Product Change Notice (PCN)

PCN Number: PCN-0451152R-01

Product(s) Affected: *PJ-038A, PJ-038AH & PJ-038BH*

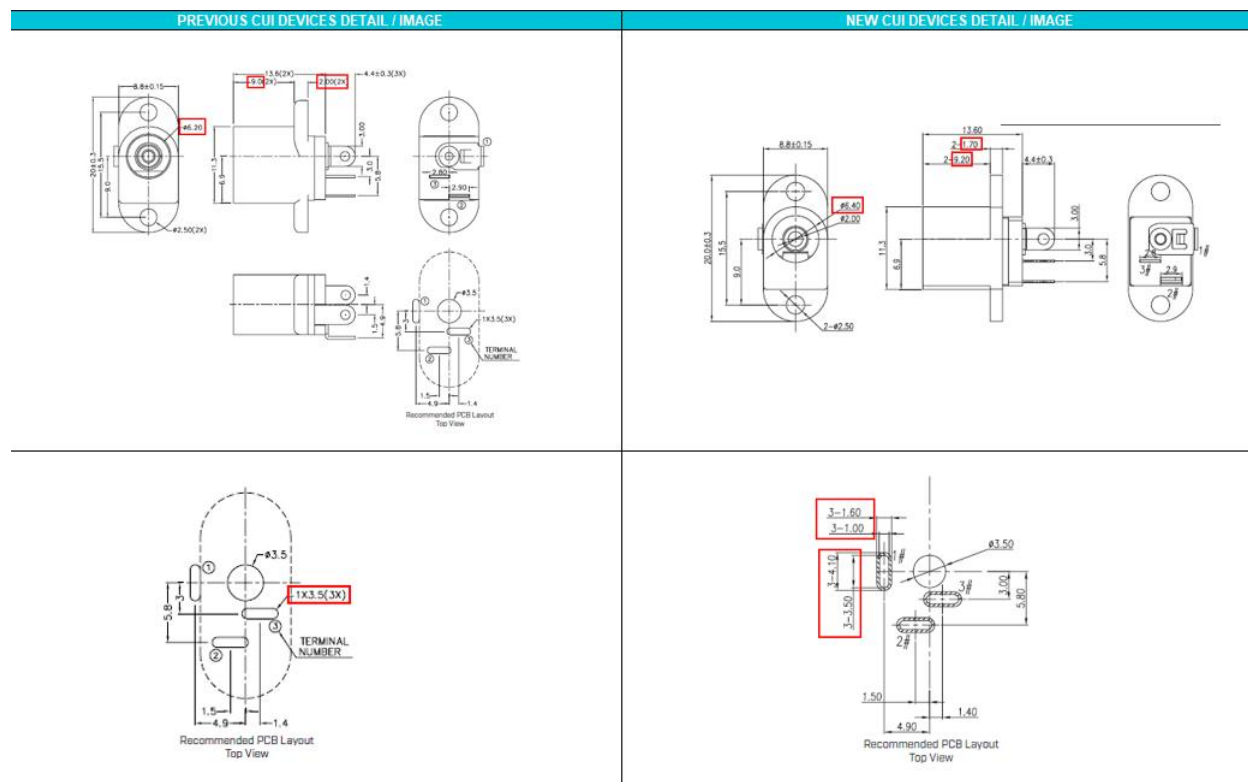
Description of Change: *Mold Change. Minor dimensional differnces. See image Below*
